## MEMORANDUM

**DATE:** August 14, 2008

**SUBJECT:** SFWMD Responses to the Peer Review Panel Task 3 Report for the Kissimmee Basin Modeling and Operations Study (KBMOS)

Figure 2.21 MIKE SHE River Links and Floodcodes used in the KBMOS model.

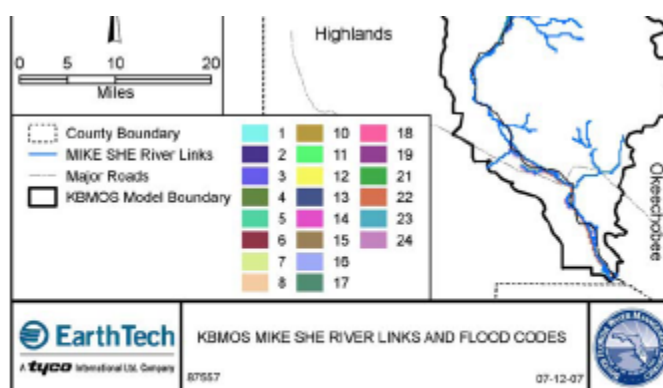
12. (DPL) In Figure 2.21, where are the flood codes defined? p. 2-44.

Requires update to AFET Documentation Report, see Memorandum Summary at the end of this document.

Figure 5.80 Simulated and observed water level at UFA ORA 017/GS 825 during the verification period.

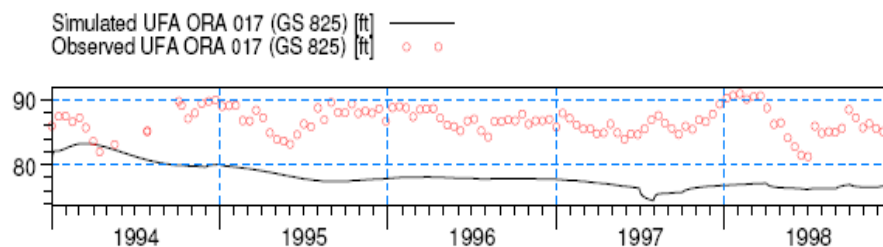
1. (DPL) Calibration results illustrated on pages 4-19 – 38, and the verifications are generally impressive. Perhaps the worst on is shown in Figure 5.80. Any reasons? p.5-26.

Addressed in teleconference, no action required

Figure 5.101 Simulated and observed discharge at S57 during the storm verification period.

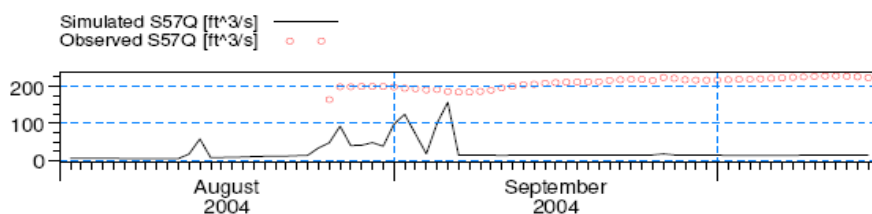
3. (DPL) Figure 5.101 shows a poor fit. p. 5-45. Why?

Addressed in teleconference, no action required

Figure 5.144 Simulated and observed discharge at S65D during the storm verification period.

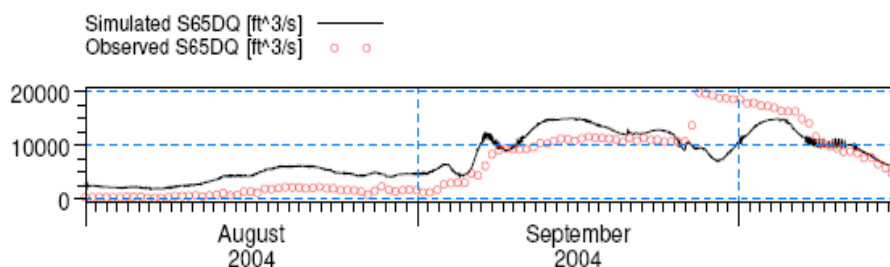
4. (DPL) Figure 5.144 suggests to me there was some inflow to the system in late September 2004 that the model data base doesn't have. Is that true? P. 5-56

Addressed in teleconference, no action required

Figure 4.9 Observed stage at KRBNS and PC45 in the restored portion of the Kissimmee River during the calibration period.

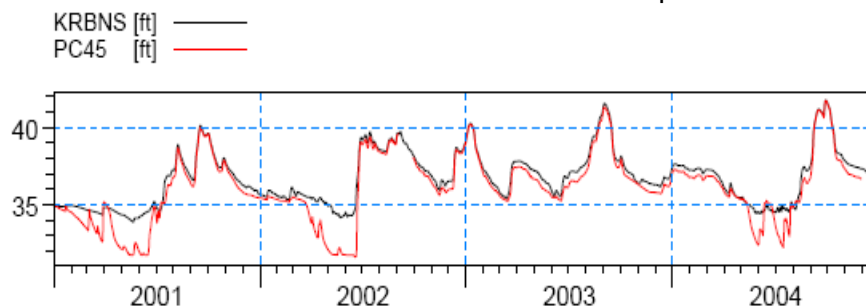
5. (DPL) Figure 4.9. What causes these occasional mismatches? p. 4-16

Addressed in teleconference, no action required

**Figure 4.62** Simulated and observed water depth at PA1F during the calibration period.

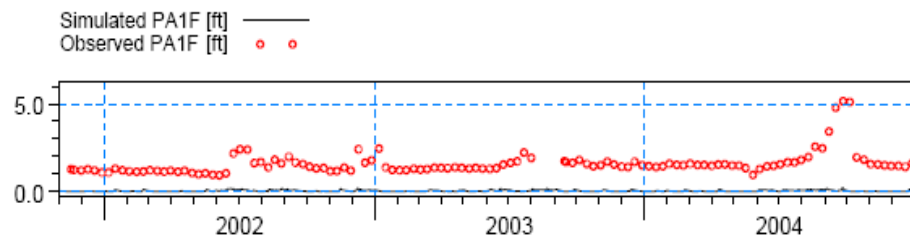
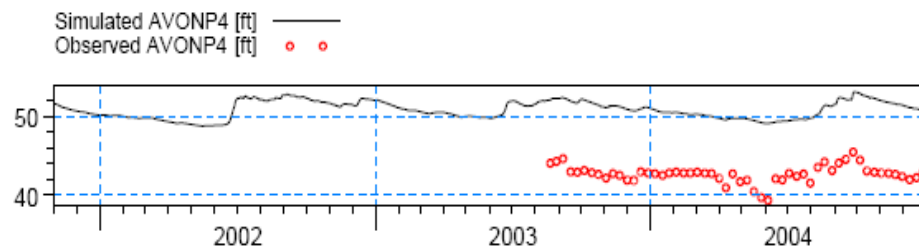
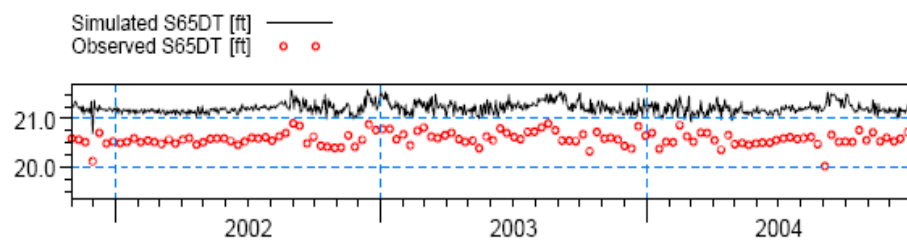
6. (DPL) Are there datum problems in the following Figures?

[Addressed in teleconference, no action required](#)

Figure 5.106 Simulated and observed tailwater stage at S59 during the storm verification period.

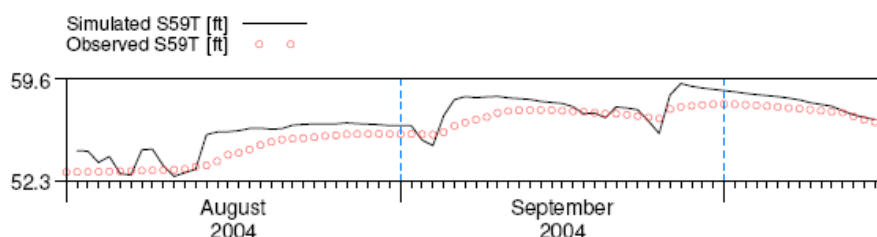
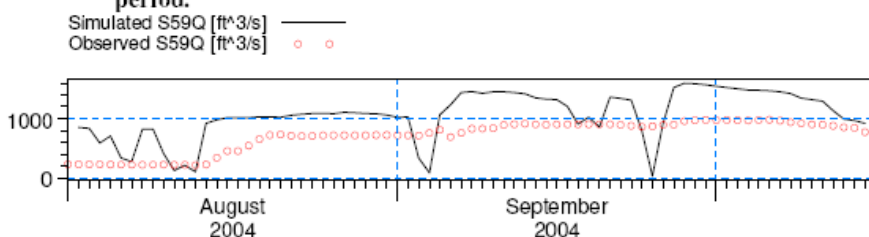
8. (DPL) Figures 5-106 and 107 suggests to me that perhaps the model doesn't take into account the dampening of variations in stages as it should during hurricanes. Is there another reason?

Addressed in teleconference, no action required

Figure 2.21 MIKE SHE River Links and Floodcodes used in the KBMOS model.

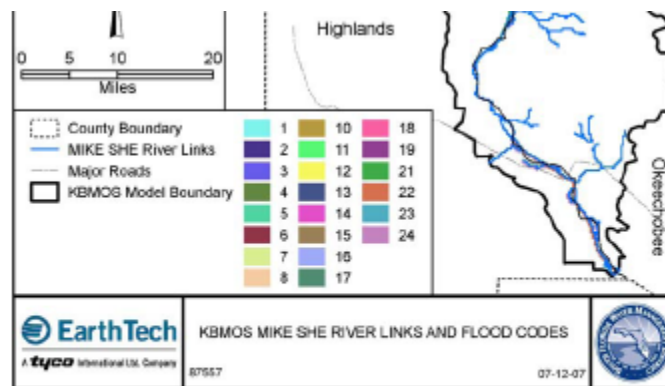
12. (DPL) In Figure 2.21, where are the flood codes defined? p. 2-44.

Action: clarification added to the text that the referenced flood codes identify geography, not a numerical model input parameter.

Figure 1: L Performance Measures

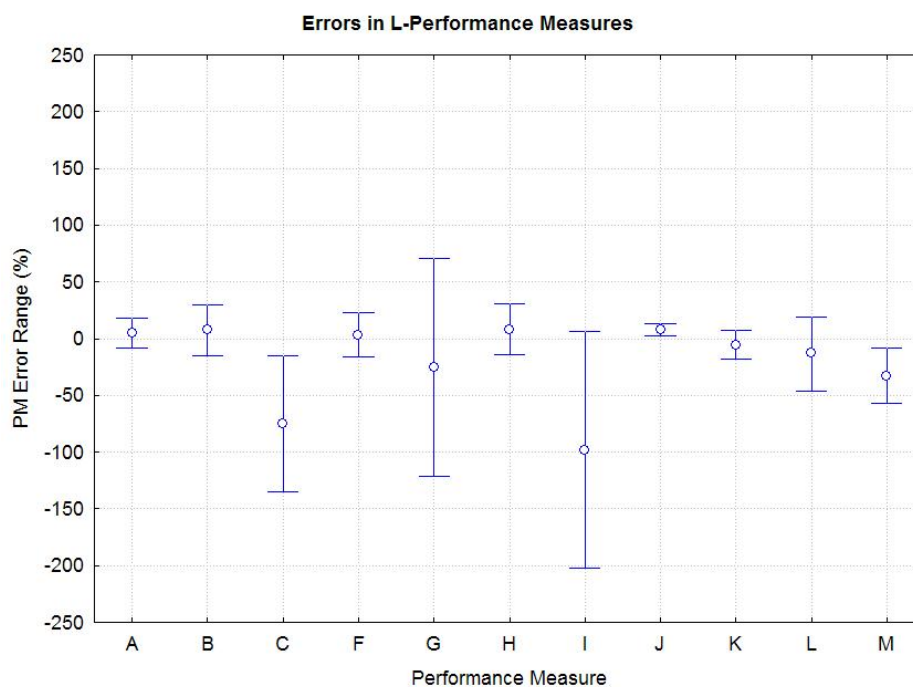
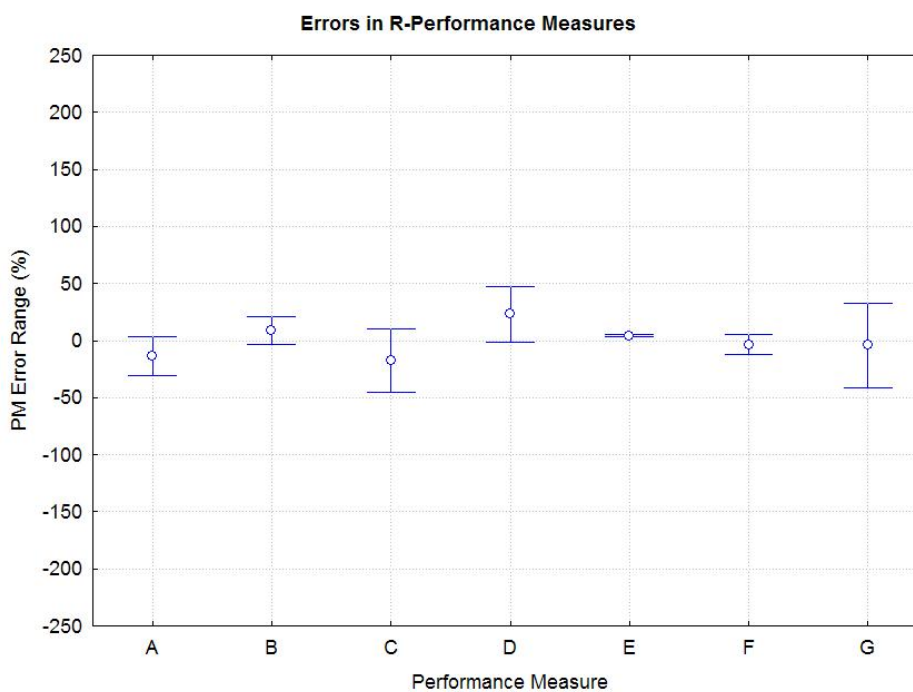
- Analysis of the validation results obscures the magnitudes of the discrepancies in the performance measures, and does not take advantage of the opportunity to use the discrepancies as a measure of the uncertainty in the performance measures. To illustrate this point, the mean percentage errors and one standard deviation error bars in the lake and river performance measures are shown in Figures 1 and 2 respectively. These results are derived from Appendix B, and give a direct indication of the error ranges to be expected from each of the performance measures, where the errors are due only to model structure. For example, lake performance measure B can be expected to have a one-standard deviation error range between  $B-23\%B$  and  $B+23\%B$ . This could be particularly useful in discriminating between alternatives in the screening process. Such an uncertainty component is essential in the ranking and screening of alternatives. Failure to adequately account for this uncertainty could potentially be a critical flaw.

KMBOS Performance Measures continue to evolve and it is sometimes difficult to separate true differences in model results and false differences caused by the current formulation of the PM. To minimize risk, the project team examines both the PM scores of all Alternatives and their hydrologic behavior as well. Once the PM tools mature, the discrimination tests proposed above can be developed.
